Executive Order G-70-25-C

Relating to the Modification of the Certification of the
Atlantic Richfield Balance
Phase II Vapor Recovery System

**ATLANTIC RICHFIELD COMPANY BALANCE PHASE II
VAPOR RECOVERY SYSTEM**

EXHIBIT 1

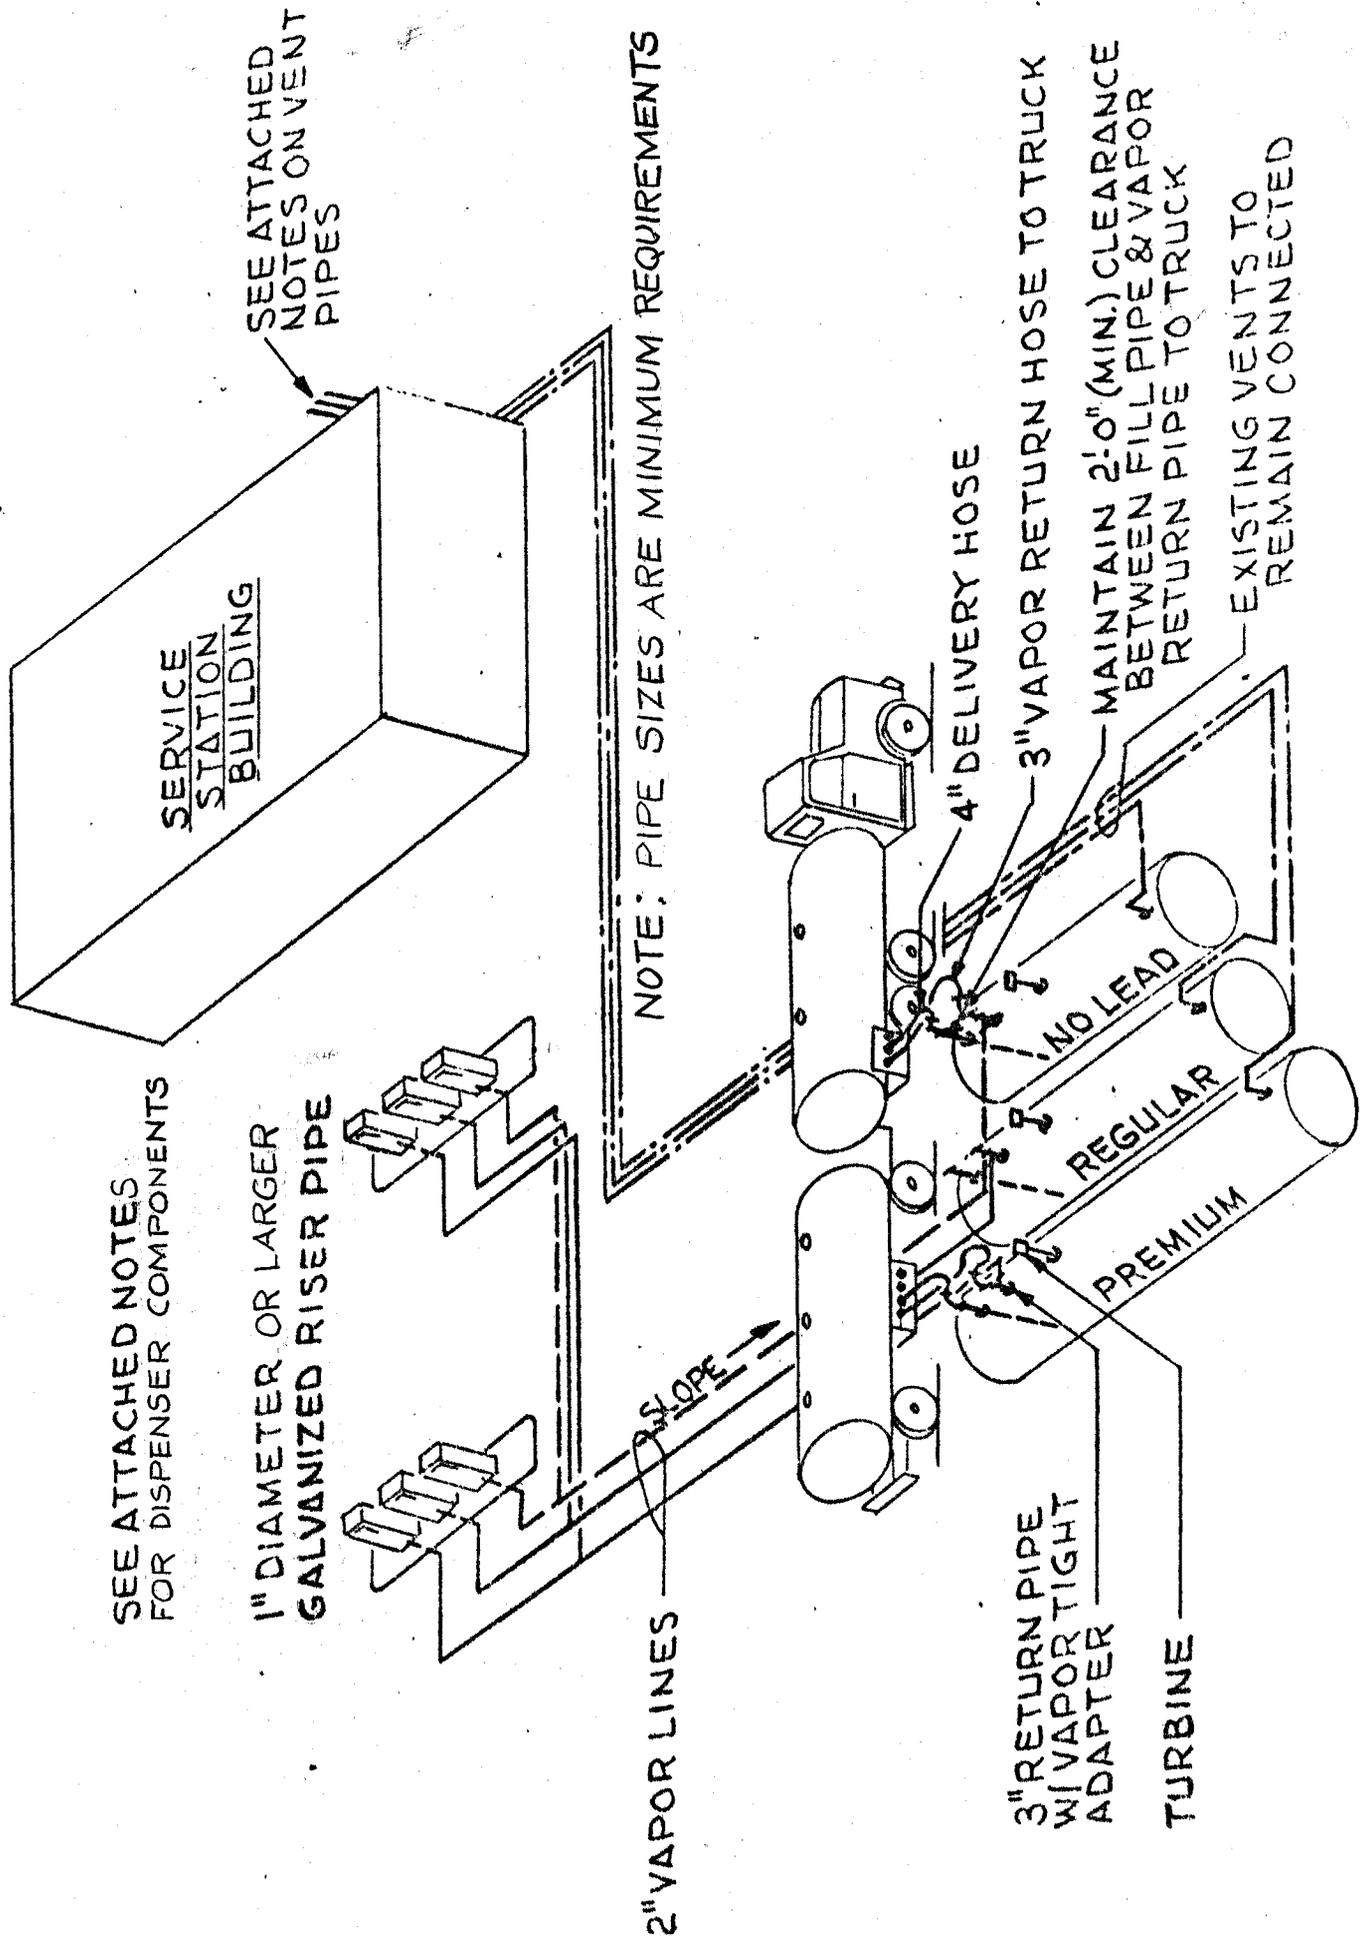
IT IS ORDERED AND RESOLVED: That the certification Executive Order G-70-25-B issued on August 3, 1979 for the Atlantic Richfield balance Phase II vapor collection and disposal system is hereby modified to include OPW-7VC nozzles as alternate nozzles. The system hereby modified is certified to be at least 95% effective in self-serve and/or attendant use at gasoline service stations in conjunction with Phase I vapor recovery systems which have been certified by the Air Resources Board. The system is described in Exhibits 1 and 2, attached hereto.
